ARINC INCORPORATED

Application for Blanket Authority to Operate  
Up to One Thousand Technically Identical Ku-  
Band Transmit/Receive Airborne Mobile  
Stations Aboard Aircraft Operating in the  
United States and Adjacent Waters

File No. SES-LIC-20030910-01261

**RESPONSE OF ARINC INCORPORATED**

Figure 5-1 Off-Axis Aggregate EIRP Limit and "EIRP Mask"

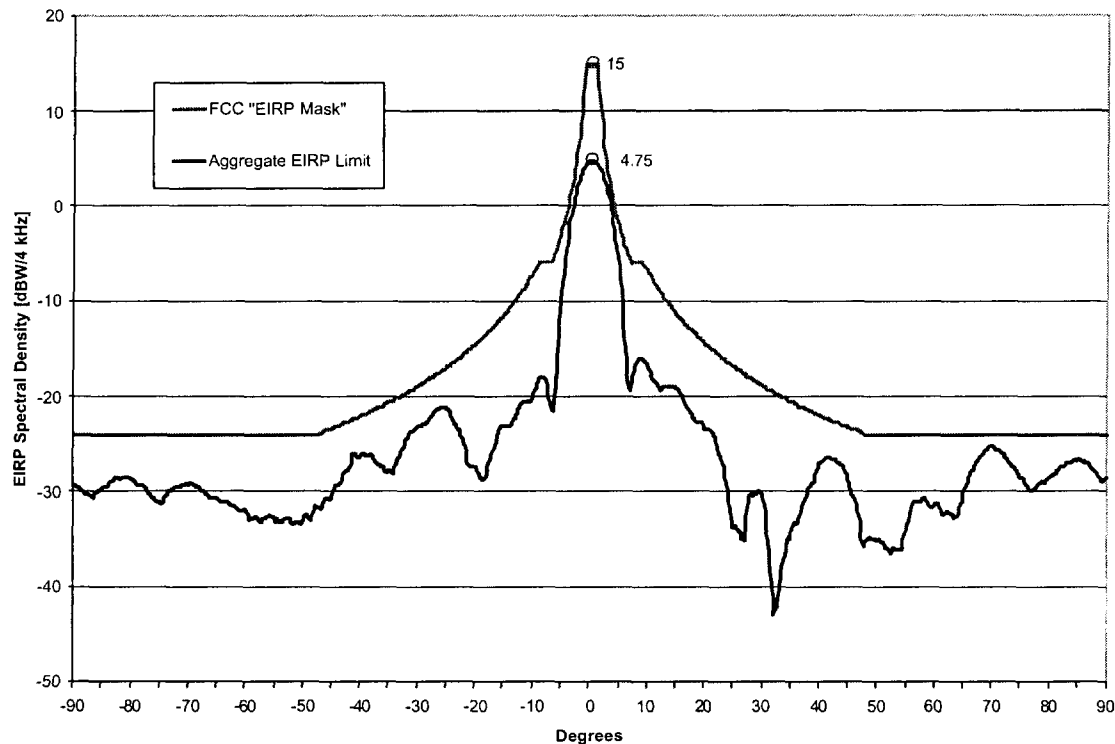
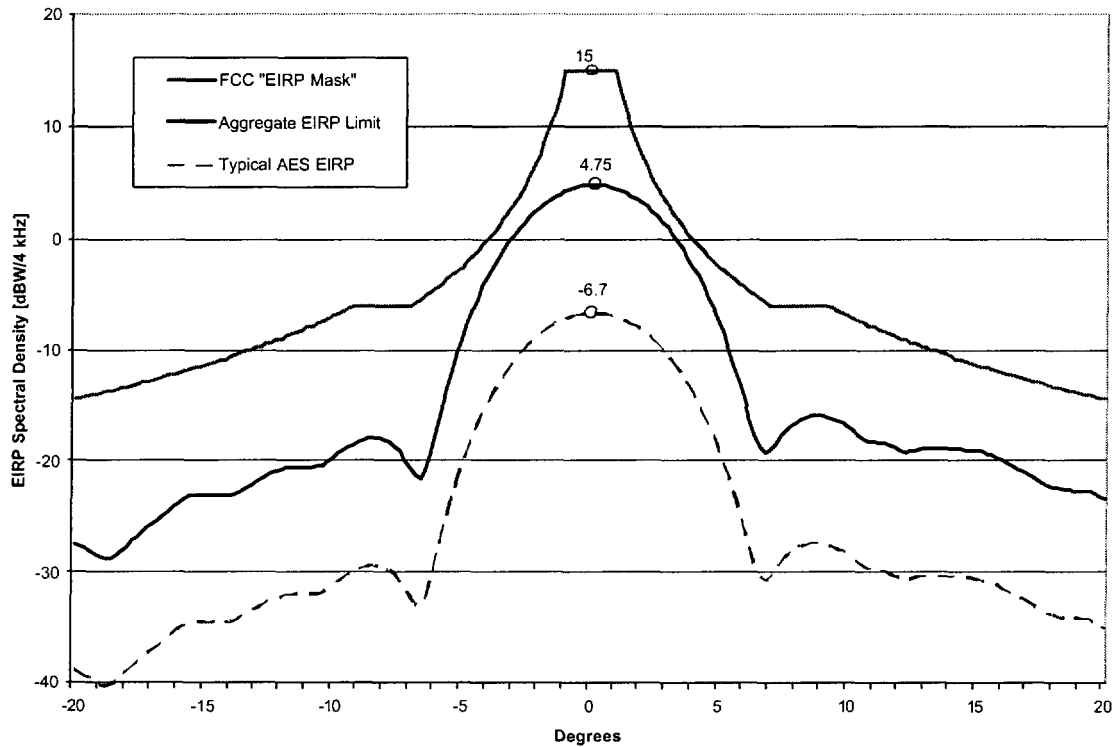
As Boeing correctly points out, the discussion in Section 5.2.1 of the Technical Description incorrectly uses the terms 'E.I.R.P.' and 'input PSD'. The value -24.25 dBW/4 kHz is more appropriately defined as the aggregate input power spectral density limit and not an e.i.r.p. density limit. This number is derived from the FCC limit in 25.134(a) which defines an antenna input power spectral density limit of -14 dBW/4 kHz. Because the AES antenna falls short of meeting the FCC 25.209(a)(1) mask by 10 dB at its worst point, 10 dB plus 0.25 dB additional margin was subtracted from the -14 dBW/4 kHz antenna input limit to yield an effective antenna input limit of -24.25 dBW/4 kHz. Corrections to the relevant figures and text in Section 5.2.1 of the Technical Description are included as Attachment 2 to this exhibit.

**Page for Page Corrections to Section 5.2.1 of the Technical Description  
[Pages 43 and 44]**

To avoid harmful interference to other FSS systems from the Return link, the ARINC SKYLink<sup>SM</sup> System will manage the aggregate EIRP spectral density of the AISTs in the plane of the GSO arc to the levels required for a routinely processed VSAT network as described in Sections 25.134(a) and 25.209(a)(1) of the Commission's Rules. That is, the aggregate EIRP spectral density of all aircraft transmitting simultaneously on the same frequency will not exceed the mask defined by an input power density of -14 dBW/4 kHz into an antenna with the sidelobe levels of Section 25.209(a)(1). This "EIRP Mask" is shown in Figure 5-1 below and has a main lobe value of +15 dBW/4 kHz. The "Aggregate EIRP Limit" shown in Figure 5-1 is defined by backing off the maximum effective isotropic radiated power spectral density from a SKYLink antenna (with a pattern comprised of the maximum of the 14.0, 14.25, and 14.5 GHz patterns in Figure 3-2) by 10.25 dB, as described in Section 3.1.2.2. The resulting EIRP spectral density has a main lobe value of +4.75 dB.

Figure 5-5 SKYLink<sup>SM</sup> Output Relative to Radio Astronomy Recommendation ITU-R M.1643

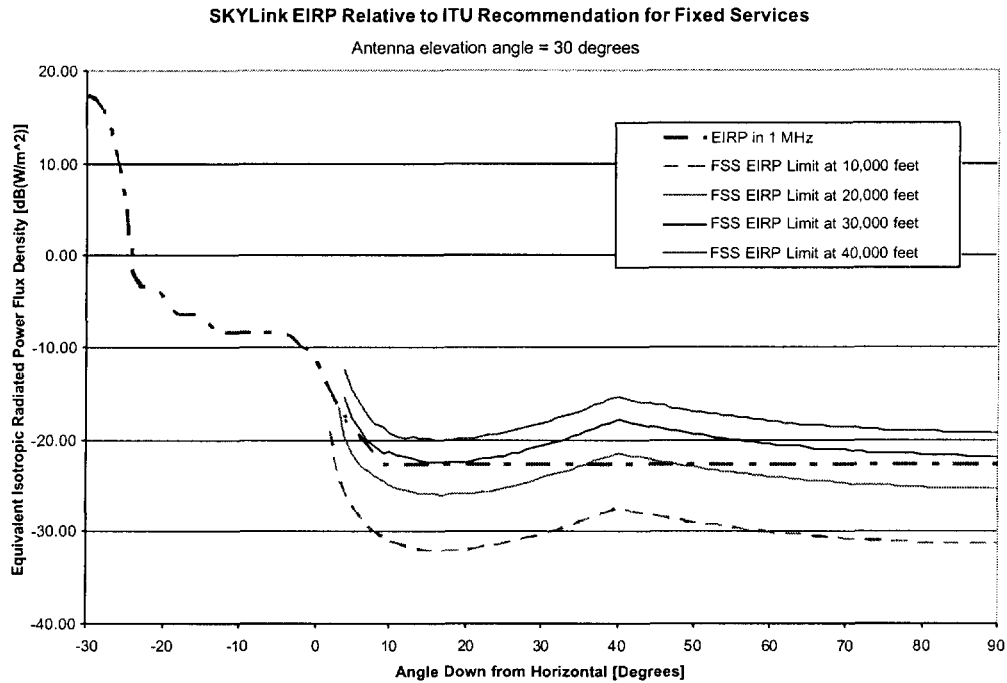
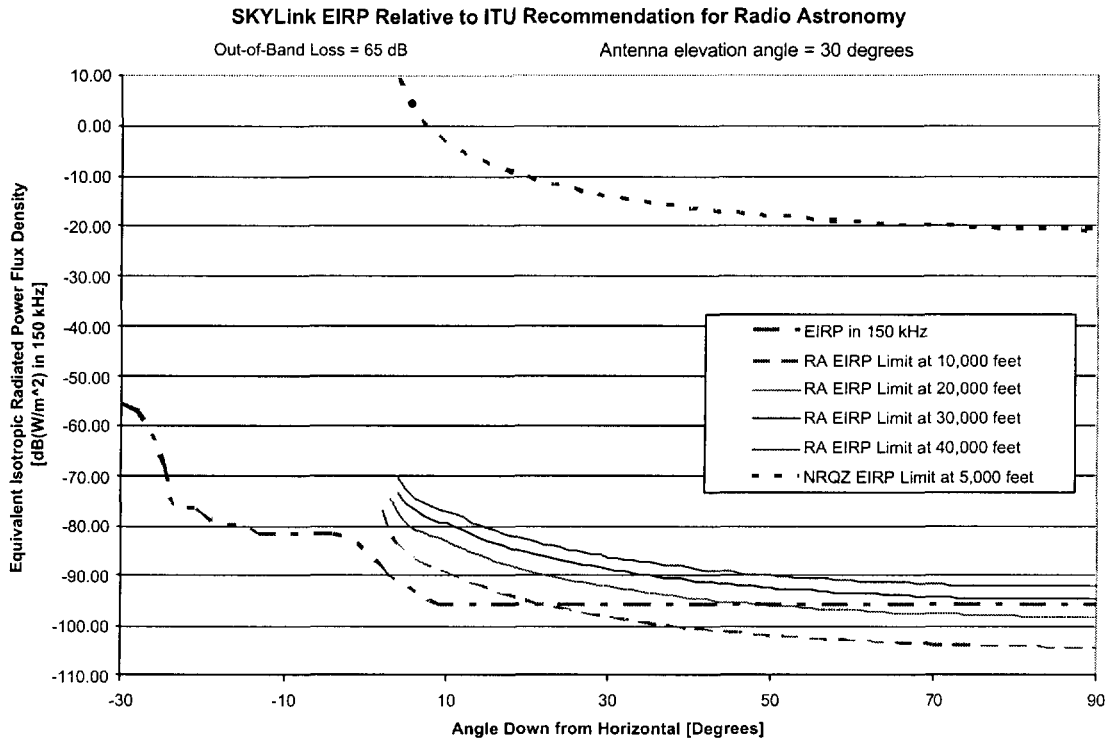
Boeing also correctly points out that calculations supporting the Radio Astronomy discussion in Sections 5.2.2 and 5.24 of the Technical Description incorrectly omitted the 30.96 dB antenna gain. Corrections to Sections 5.2.2 and 5.24 of the Technical Description are included as Attachment 3 to this exhibit. Even with this additional gain, the SKYLink antenna meets National Radio Quiet Zone restrictions for a minimum antenna elevation of 10 degrees at all aircraft altitudes of 10,000 feet or higher. The SKYLink antenna pattern does not allow us to categorically claim that radio astronomy stations are protected by the system design – even when airframe masking is taken into account. Radio Astronomy sites are, however, protected as long as the aircraft is operating at or above a 30,000 cruising altitude and the SKYLink system is using only transponders 5 through 21.

To protect radio astronomy stations operating in the 14.47 to 14.5 GHz band, AESs operating with an uplink center frequency above 14.44 GHz within line-of-sight of these stations will cease transmissions. SKYLink thus complies with the Aug. 13, 2003 MoU between the FCC and NTIA that addresses AMSSs in the 14.0-14.5 GHz band. The SKYLink application will be coordinated with federal users through the IRAC process, and that process has begun. In the course of federal clearance, concurrence will have to be obtained from NSF and NASA. This coordination should be completed expeditiously, since the WRC now has spoken. Because this coordination is underway and is being accomplished in parallel with the FCC review, there is no reason to delay the SKYLink application.

**Page for Page Corrections to Sections 5.2.2 and 5.2.4 of the Technical Description**  
**[Pages 47, 48, and 49]**

To protect radio astronomy, when operating on transponders with an uplink center frequency above 14.44 GHz within the line-of-sight of a radio astronomy station operating in the 14.47 to 14.5 GHz band, the AISTs will cease transmissions in this band. When operating on transponders with an uplink frequency at or below 14.44 GHz, ARINC will ensure that emissions in the 14.0 to 14.47 GHz band meet the PFD limits set forth in the Recommendation.<sup>9</sup> These limits are  $-190 + 0.5 \cdot T$  dB(W/m<sup>2</sup>)/150 kHz for  $T \leq 10^\circ$ ; and  $-185$  dB(W/m<sup>2</sup>)/150 kHz for  $10 < T \leq 90^\circ$ . As shown in Figure 3-4, the out-of-band emissions from an AIST are at least 65 dB down at frequencies more than 30 MHz from the band edge. With the antenna elevation adjusted down to 30° above horizontal (worst case CONUS) and the aircraft operating above 30,000 feet, the SKYLink<sup>SM</sup> System, operating at or below 14.44 GHz, complies with the recommendation. See Figure 5-5, which includes the effects of airframe masking and out-of-band frequency attenuation.
